# Technical Service Bulletin

Technical Service Bulletin: TSB190018	Released Date: 25-Mar-2019
Lubricating Oil Pumps with Unexpected Oil Pressures

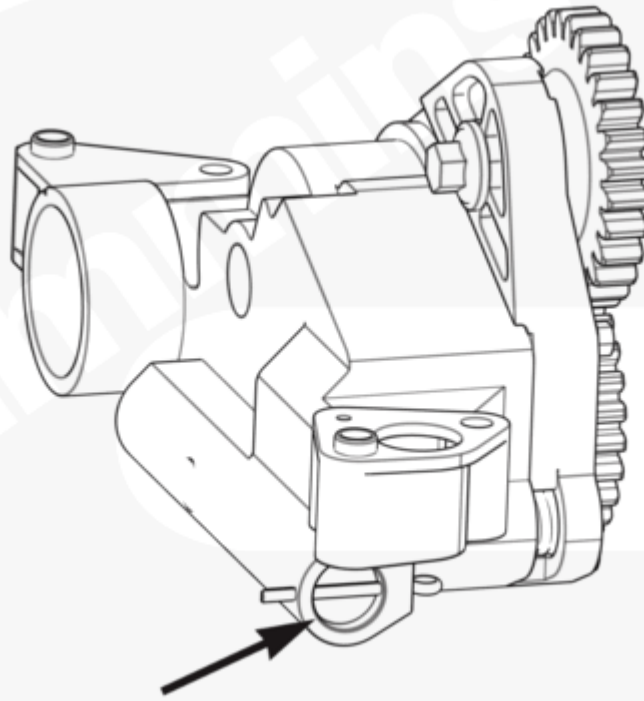
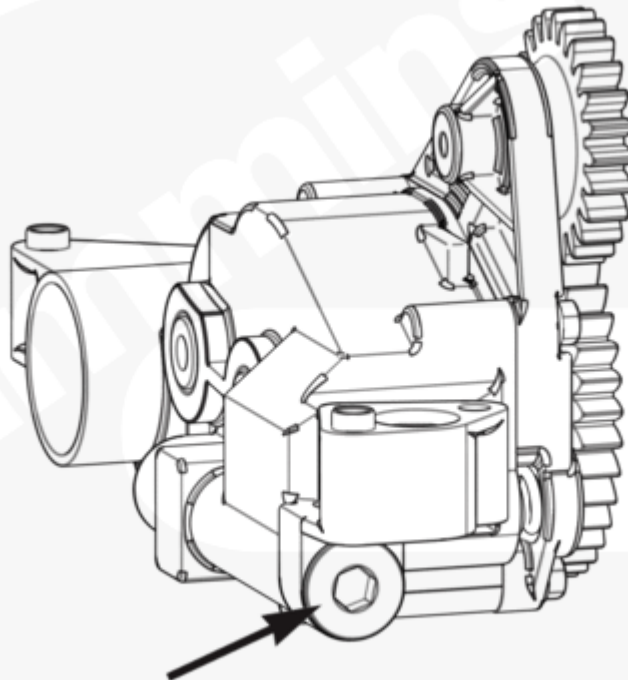
A new cast iron lubricating oil pump, Part Number 5532492, was released to replace an existing aluminum lubricating oil pump, Part Number 3687527, and cast iron lubricating oil pump Part Number 3687528, for some 15L engines. New Part Number 5532492 has different flow characteristics that do **not** affect lubricating oil system function, but can result in different oil pressure values than expected. Part Number 5532492 does **not** use shims to set gear lash like existing lubricating oil pump Part Numbers 3687528 and 3687527.

Lubricating oil pumps can be identified by the style of the regulator plug on the bottom of the lube pump. The new pump has a threaded plug. Existing pumps have a pinned plug. Pumps can also be distinguished by part numbers on the pump housings. See Figures 1 and 2 below.

New lubricating oil pump is backwards compatible, and interchangeable on engines using existing lubricating oil pumps. New pump does **not** use shims to set gear lash. For instructions on measuring and setting gear lash, see corresponding Service Manuals. Reference section 007-031.
